ISSUED TO PLANNING
DEPARTMENT
06 JUNE 2022

PROJECT NAME:
PANORAMA WELLNESS CENTRE, 1380 UPPER CANADA STREET, WASTE ENCLOSURE

DRAWING TITLE:
New Exterior Waste Enclosure Details

DRAWING NO.
ASK-A01

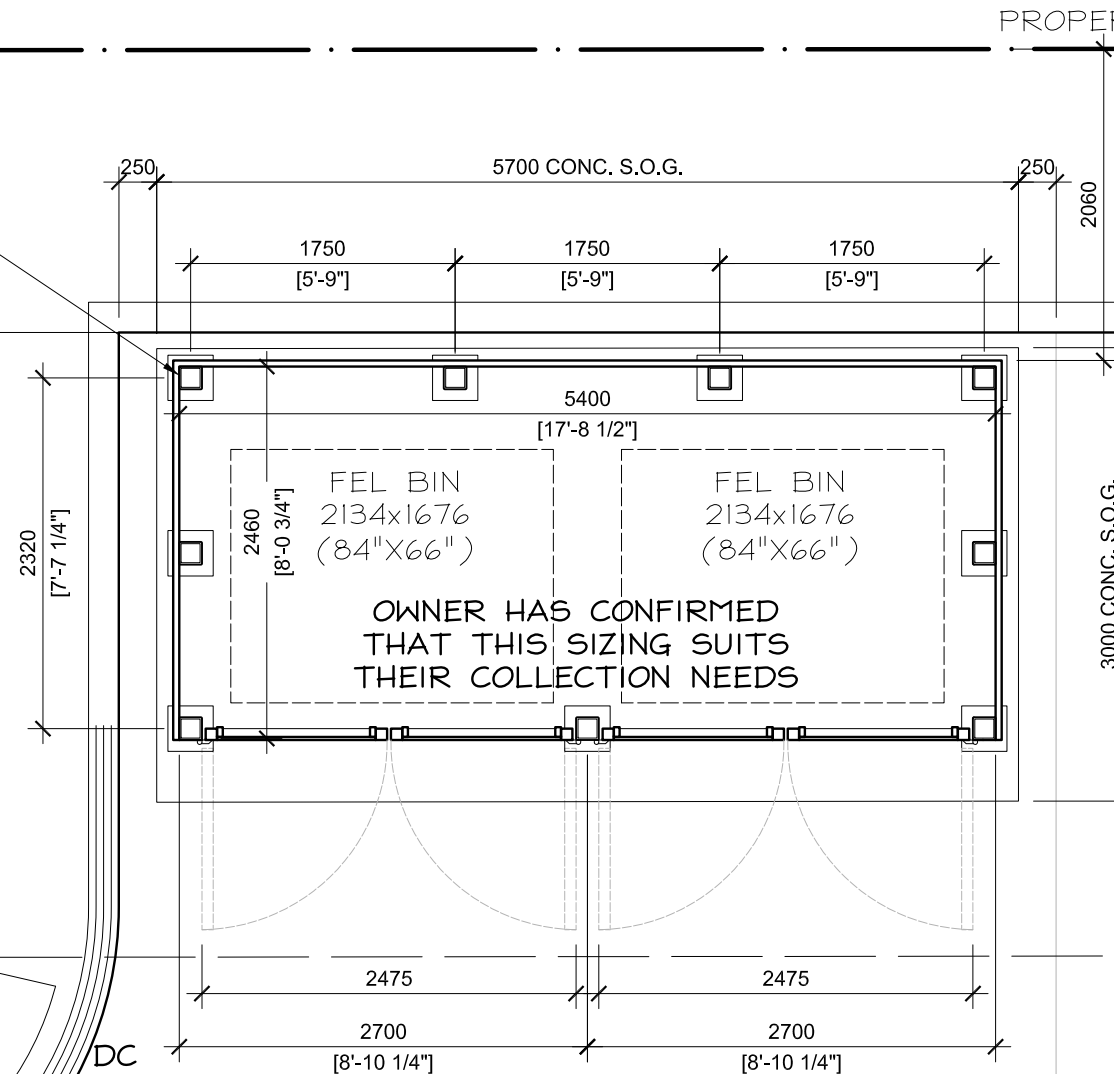
OWNER HAS CONFIRMED
THAT THIS SIZING SUITS
THEIR COLLECTION NEEDS

PROVIDE DETAILED SHOP
DRAWINGS FOR STEEL AND
ANCHORAGE, SEALED BY
P.ENG. INCLUDE HINGES
AND GATE LATCHES
